PERMIT NUMBER: B 20002731

RE: Waiver Approval
1019 Fairlane Road
Woodbine, MD 21797

Re: B20002731
1019 Fairlane Road
Woodbine Md 21797

HOUSE LOCATION DRAWING

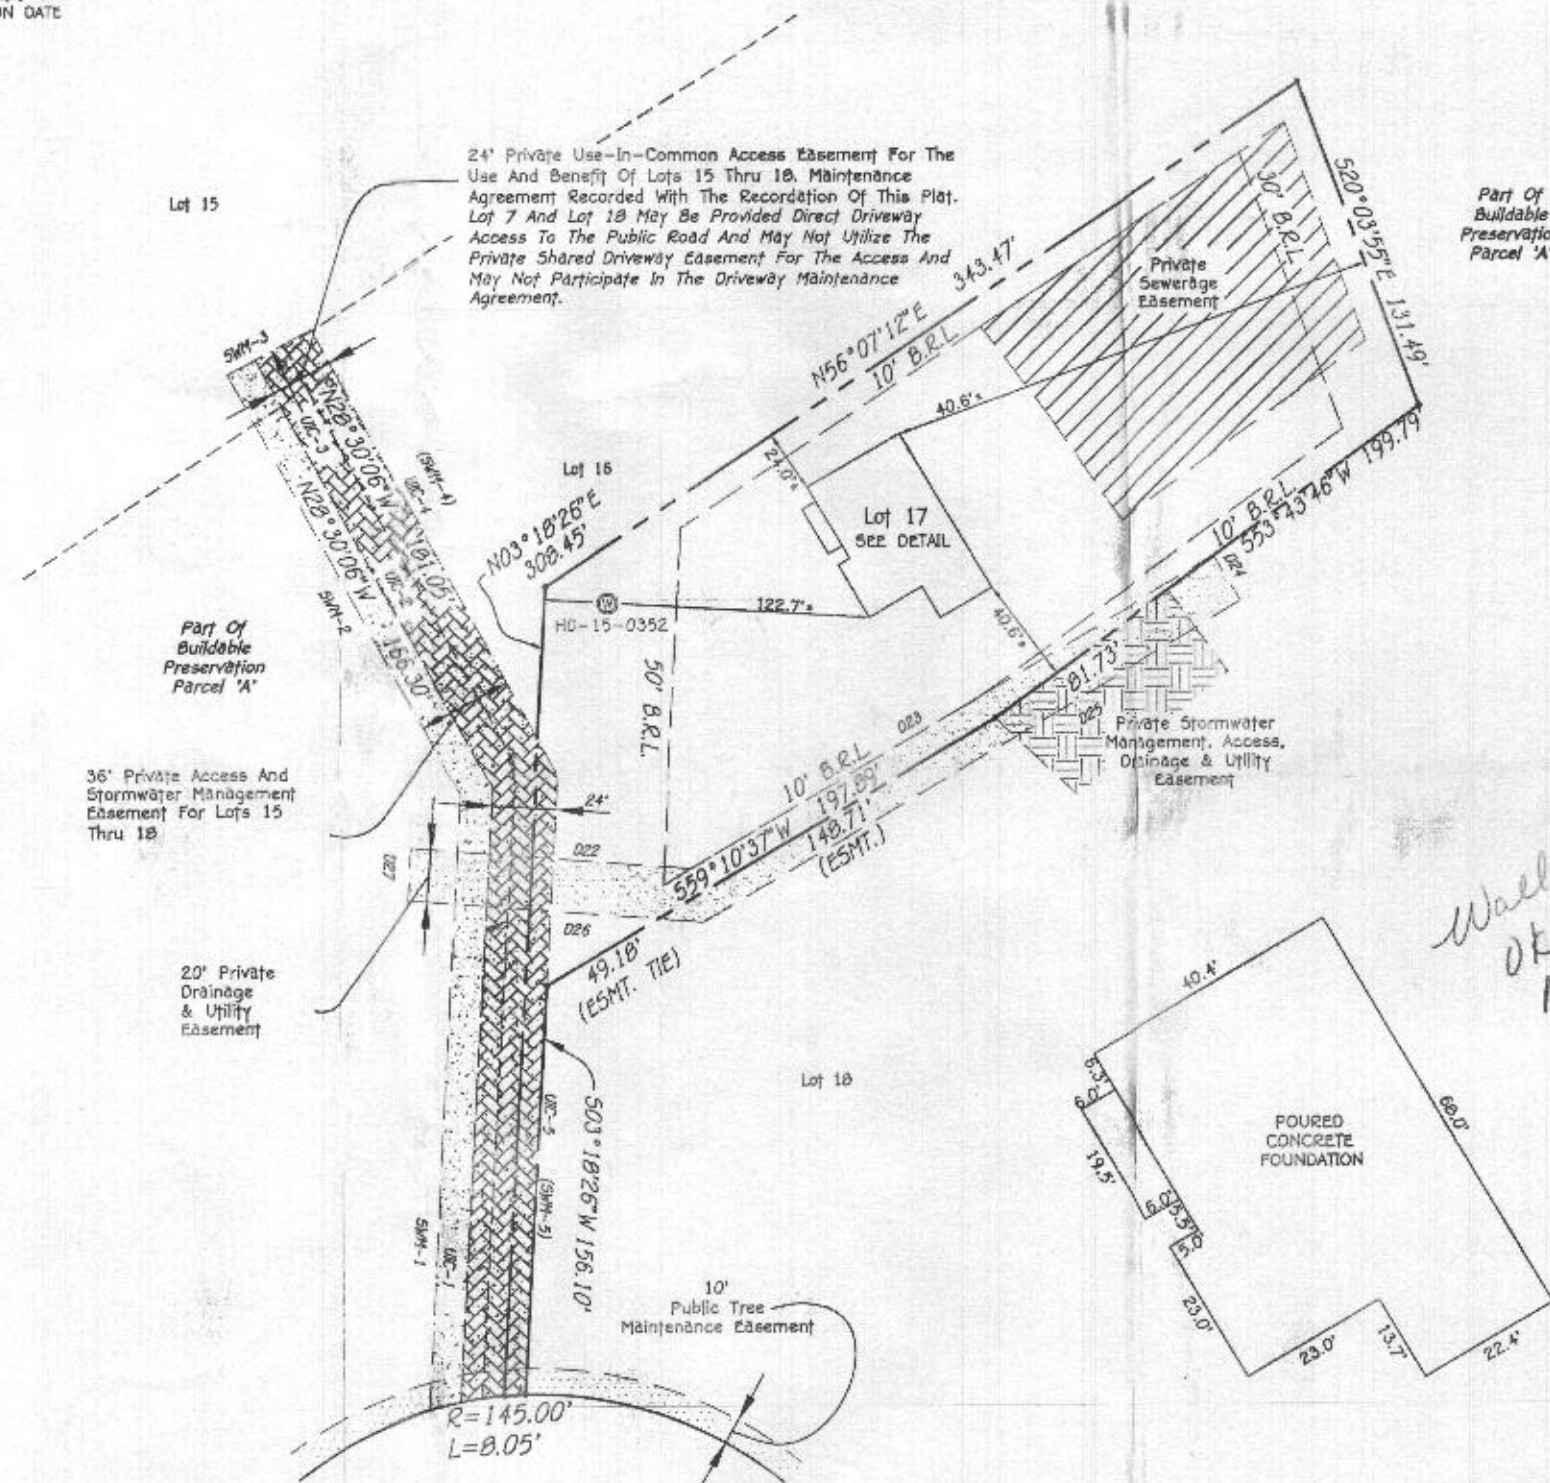
We have some leeway there and 2' isn't that tall, but we should see how close at its closest point and get any info on drainage pipes. I'd look for at least 5' if no drainage pipe assuming the wall is higher than the SDA. It shouldn't be too close to the tank either. We'd have to ask about the size of the gravel base and how close that would be to the tank. Look slike the pool may be closer than 20' to the SDA? I'd also look at that fence location vs existing trenches and perc results. If we need shallow zone for trenches (unlikely) we'd have to take a closer look at the fence. They'll need to give us the depth of the fence post holes and we can compare that to the trench depths. They will need to do a waiver request.

Hi Jeff- Should I treat the 24 inch high walls on this site plan as steep slopes with a 25 foot setback?

Based on the site plan, one wall appears much closer to the septic tank? Can you confirm that distance for me?

- 1.) What is the 24 inch wall closest point to the septic tank & sewage disposal area (SDA)? Made of shotcrete with verneer and coping
- 2.) Does the wall have drainage pipes? Yes 4" drain tile
- 3.) What is the size of the walls gravel base? 12"x 12"
- 4.) The required setback distance from a pool to the SDA is 20 feet. Anything closer will require a written waiver request by the homeowner to reduce the setback (from 20 ft. to ____). Please address the letter to Deputy Director, Mike Davis.
- 5.) What is the depth of the fence post inside the SDA? 24inch

The contractor said the wall is 10 feet from the septic tank. It's made of shotcrete with verneer and coping. The was has 4 inch drain tile. The walls gravel base is 12" x 12". The depth of the fence post is 24 inches. The septic record indicates the trench inlet to be at 3 feet. I believe they are going to submit a waiver letter reduce the pool distance to the SDA.

This letter is being issued in response to your waiver request dated September 10, 2020. Your request for a waiver of the Howard County Code twenty (20) setback for a pool to the existing on-site sewage disposal system trench has been **approved**. The proposed thirty-four (34) by eighteen (18) foot pool has been approved ten (10) feet from the existing on-site sewage disposal system trench. Additionally, the pool safety fencing as illustrated on the site plan may be installed in the sewage disposal area.

Be advised that a condition of this waiver requires temporary fencing to be installed five (5) feet from the tank and trenches extending across the entire property to prevent any vehicle or construction equipment traffic in that area during the construction of the pool. The temporary fencing must be installed prior to building permit approval.

Have them add the fence into the waiver. I'd call the wall ok unless the drain tile is aiming right at the tank
